TOWN OF RAYMOND  
Planning Board Agenda

**June 6, 2024**

Subject: **Gemini Valve Site Plan Application**  
**Tax Map 28; Lot 4-3**  
**2 Otter Court**  
**Raymond, New Hampshire 03077**  
KNA Project No. 22-0110-2

Our office is in receipt of your comments, dated March 22, 2024. Based on the comments, we have made the required modifications and attached revisions for final review. A response to each comment has been provided below.

REV.	DATE	DESCRIPTION	C/O	DR	CK
D	5/7/24	REVISIONS PER 3RD PARTY ENGINEERING REVIEW		BLR	CEB
C	2/23/24	REVISIONS PER PLANNING BOARD COMMENTS		BLR	CEB
B	1/18/24	REVISIONS PER 3RD PARTY ENGINEERING REVIEW		BLR	CEB
A	12/15/23	REVISIONS PER 3RD PARTY ENGINEERING REVIEW		BLR	CEB

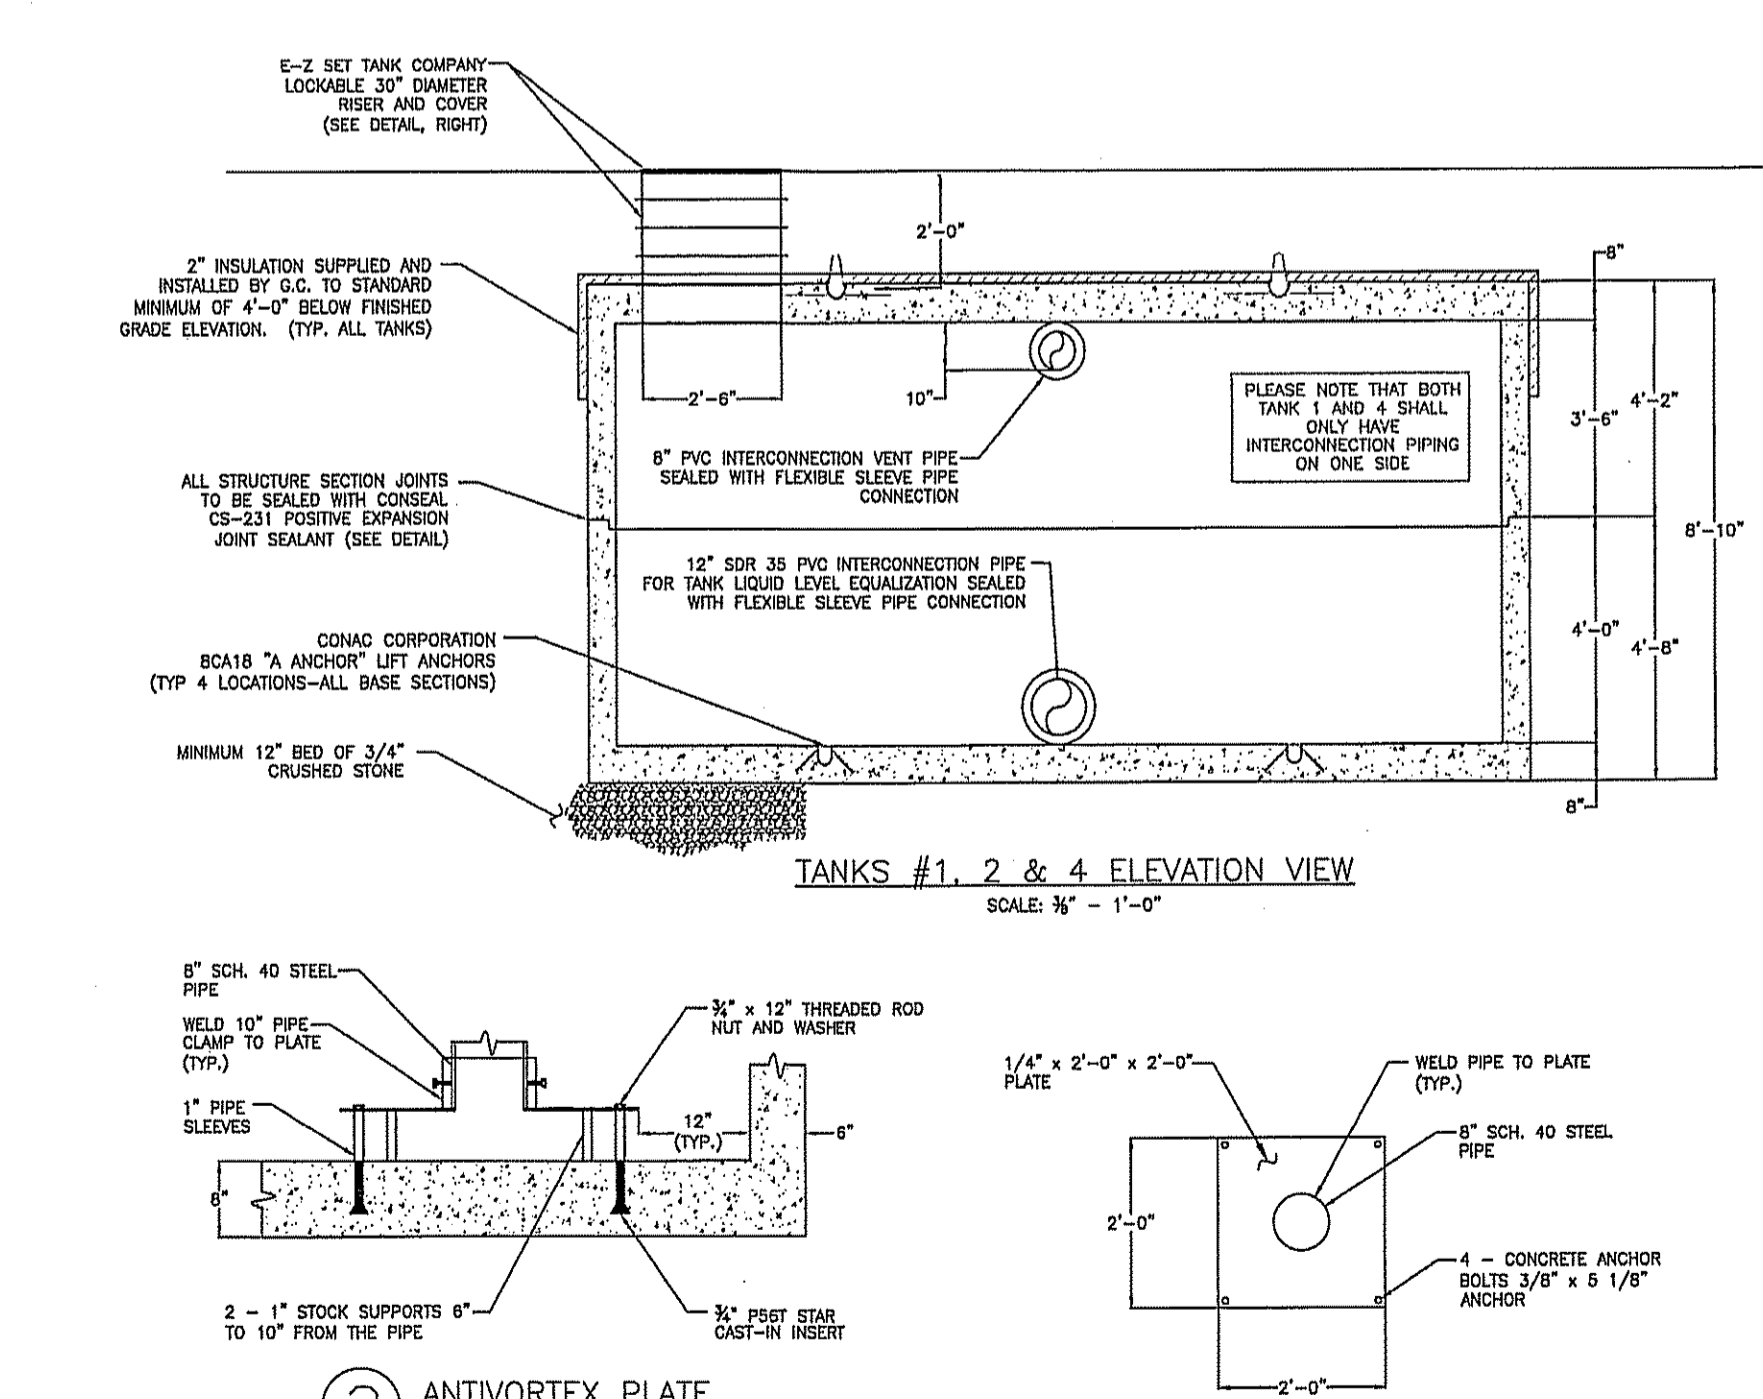
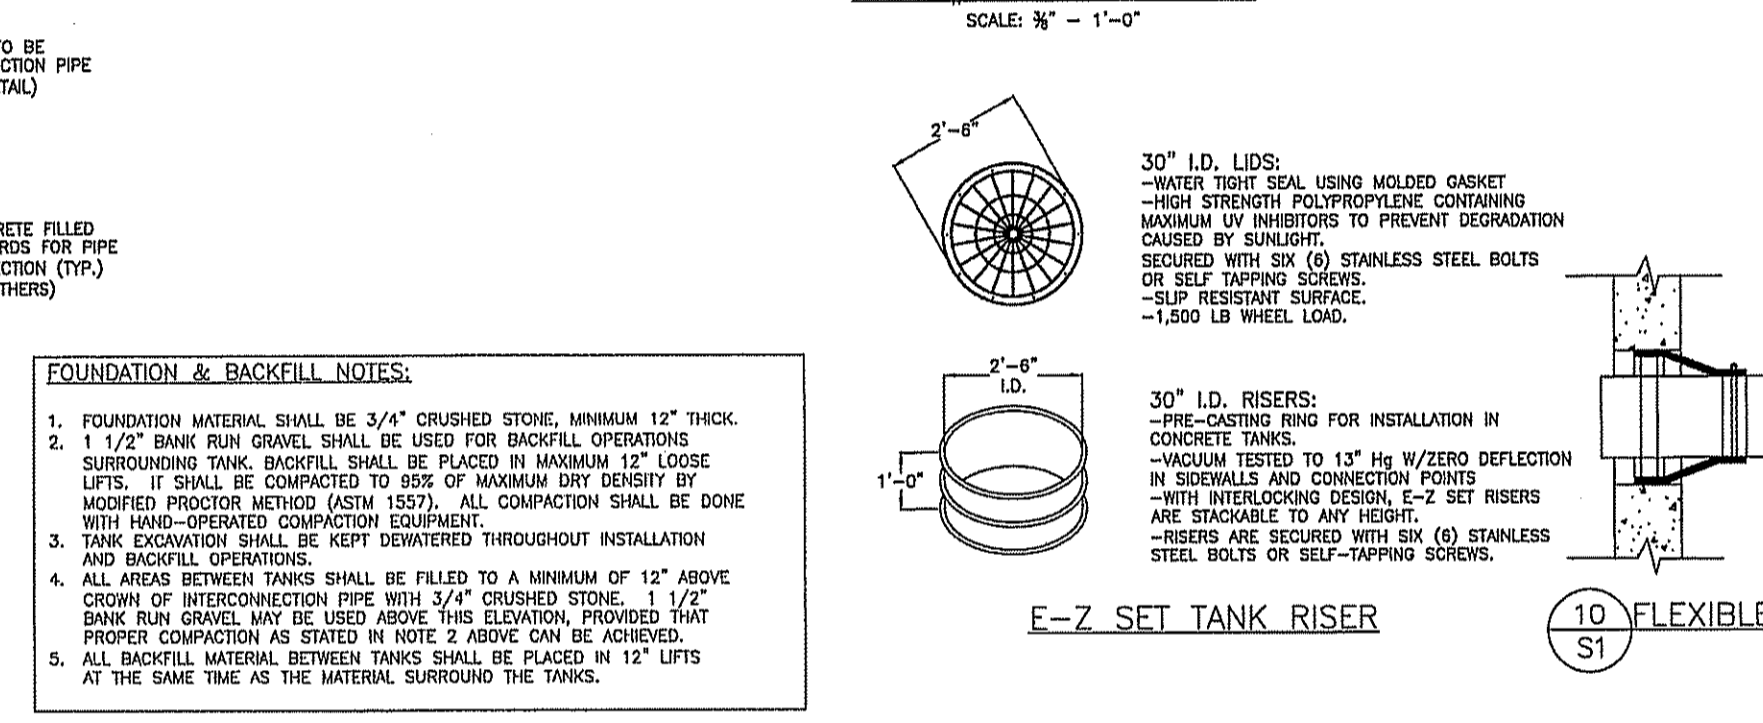
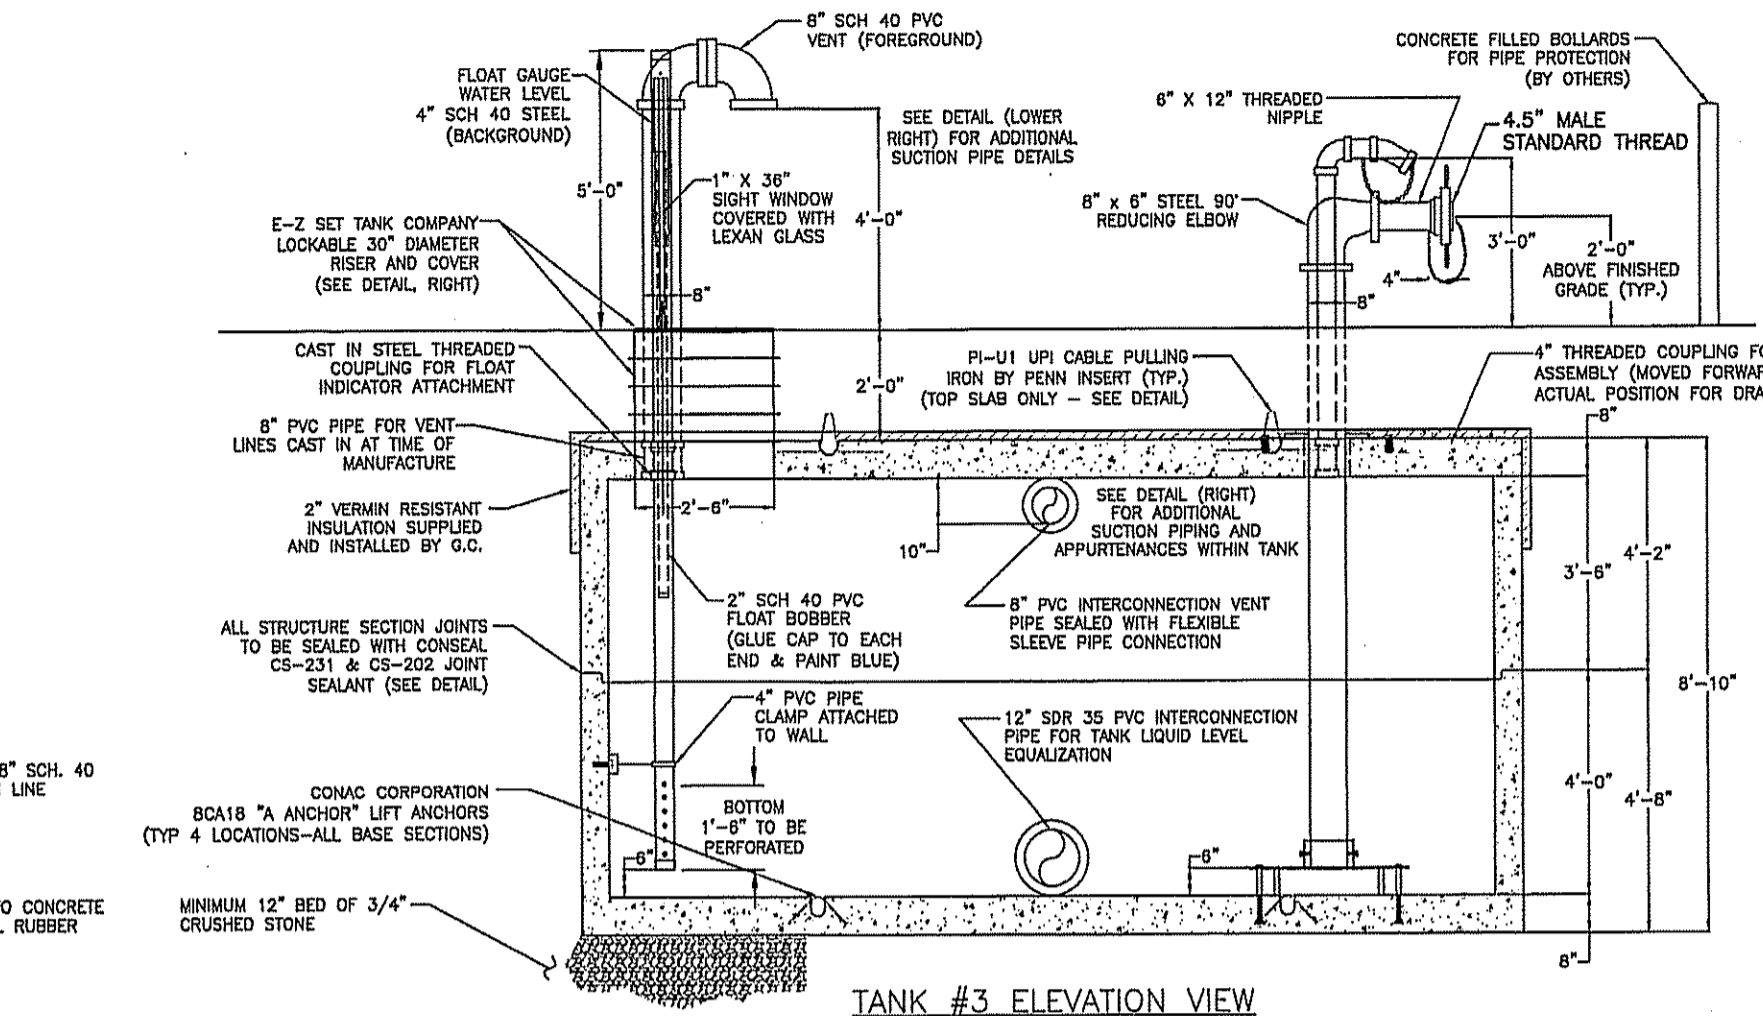
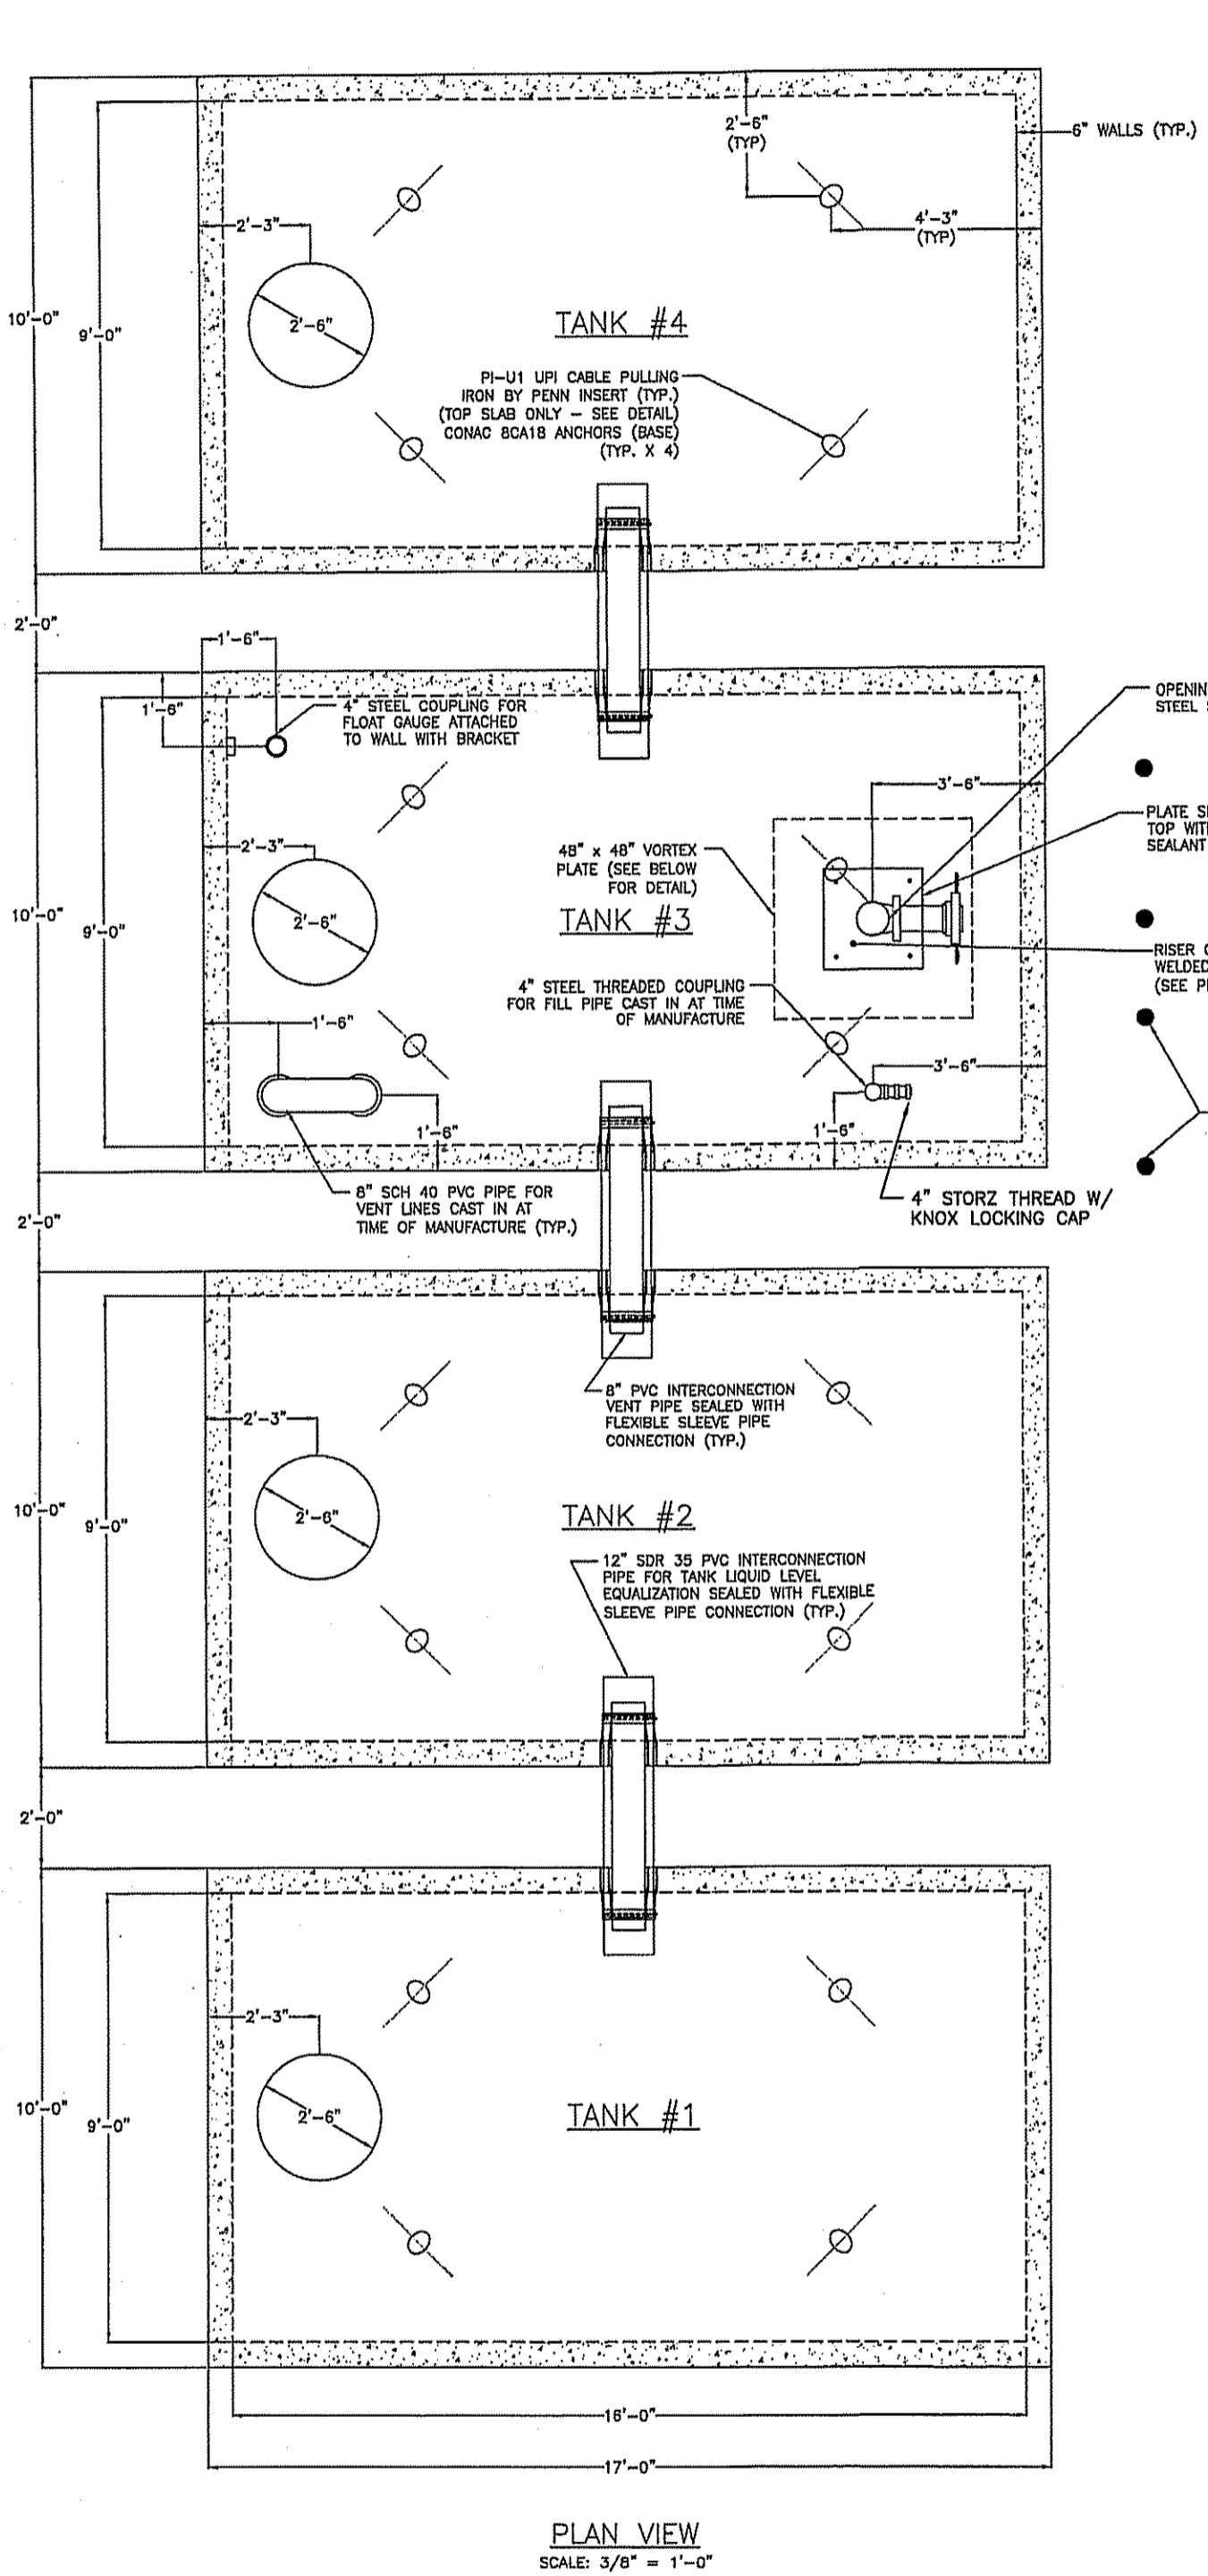
2. The emergency spillway elevation (208.70') on the rain\garden typical elevation detail (sheet 10), does not match the elevation (208.75') on the grading plan (sheet 4) or the elevation used in the drainage report (208.75'). We recommend the applicant review and revise as necessary.

*The emergency spillway elevation on detail 8, on sheet DT-3, was revised to match the grading plan as well as drainage report.*
